Test mode 6 autocorrelation improvement

Rubén Pérez-Aranda
(rubenpda@kdpof.com)

Current test mode 6 definition on P802.3bv/D3.1

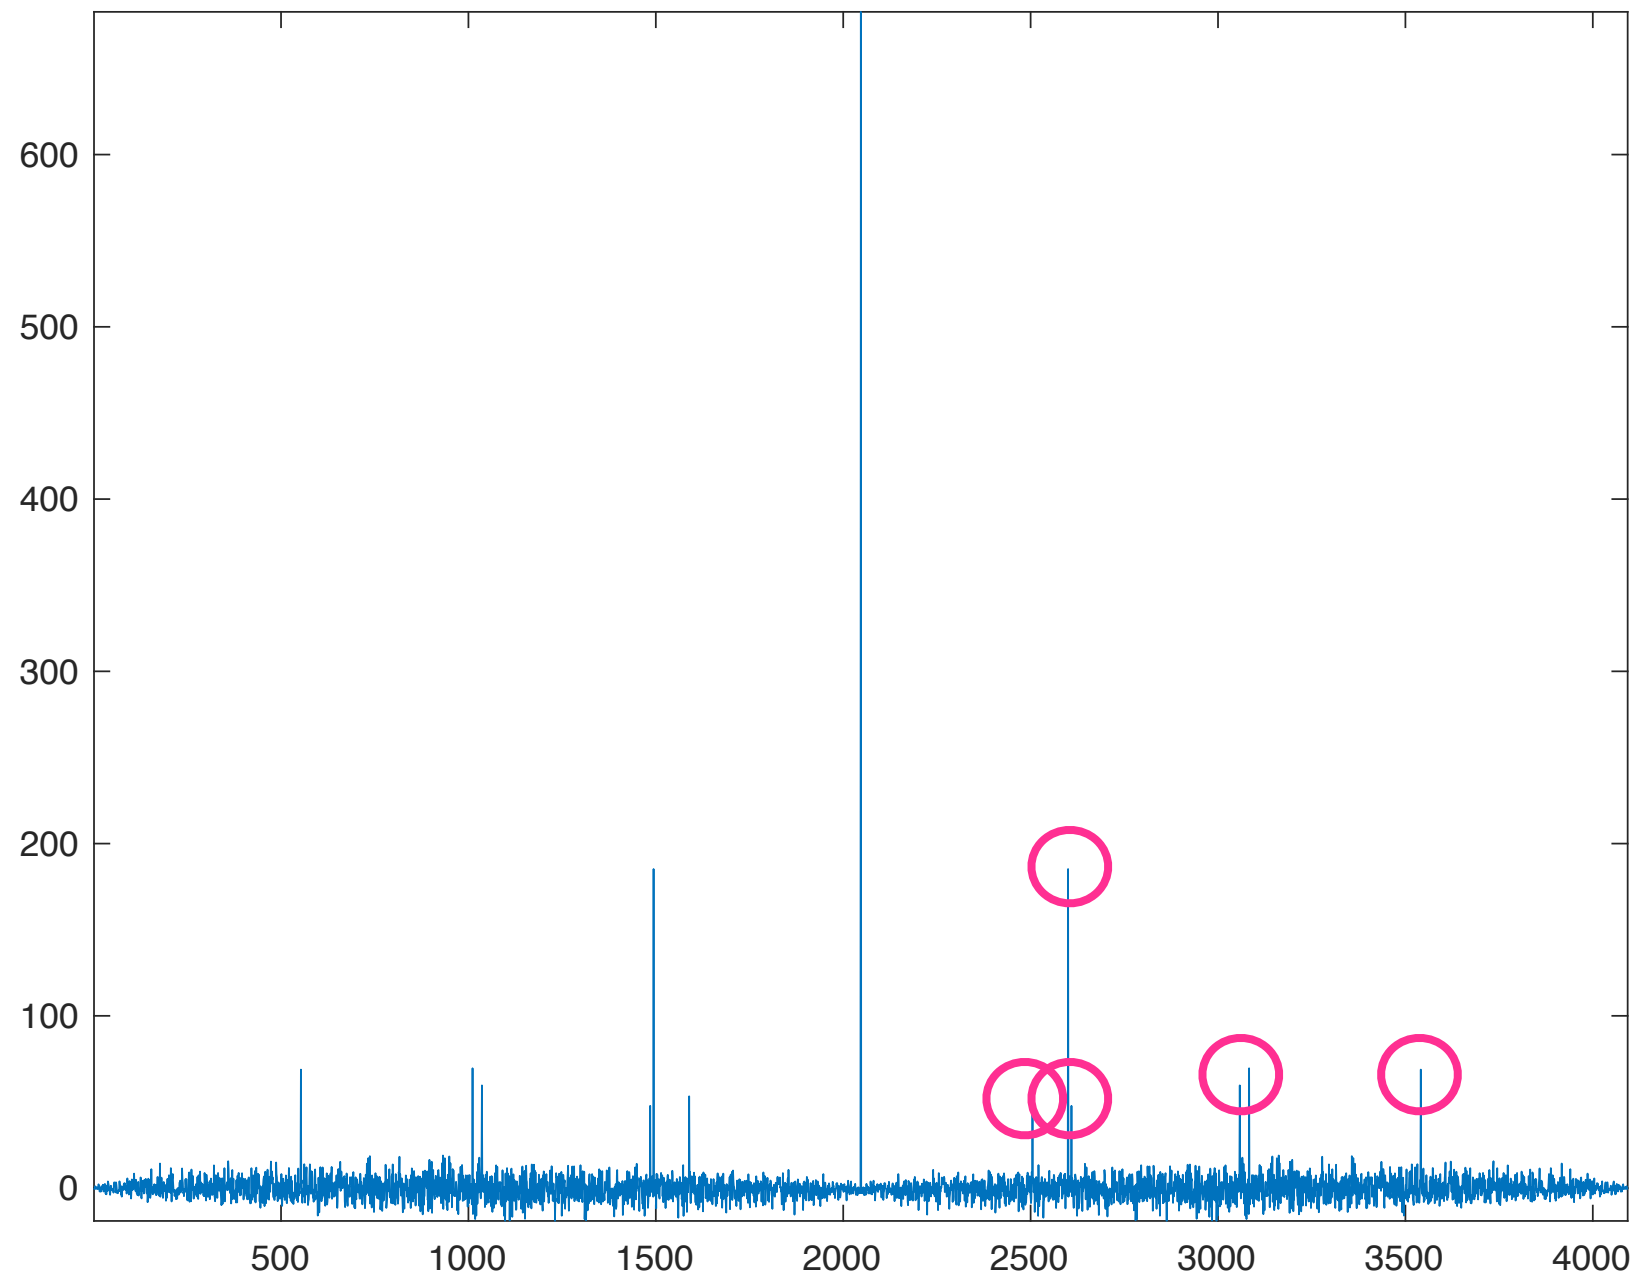
- Autocorrelation of test mode 6 signal according to 115.5.6:

Proposal for P802.3bv/D3.2 - definition II

Proposal for P802.3bv/D3.2 - autocorrelation

- Autocorrelation of proposed improved test mode 6 signal:
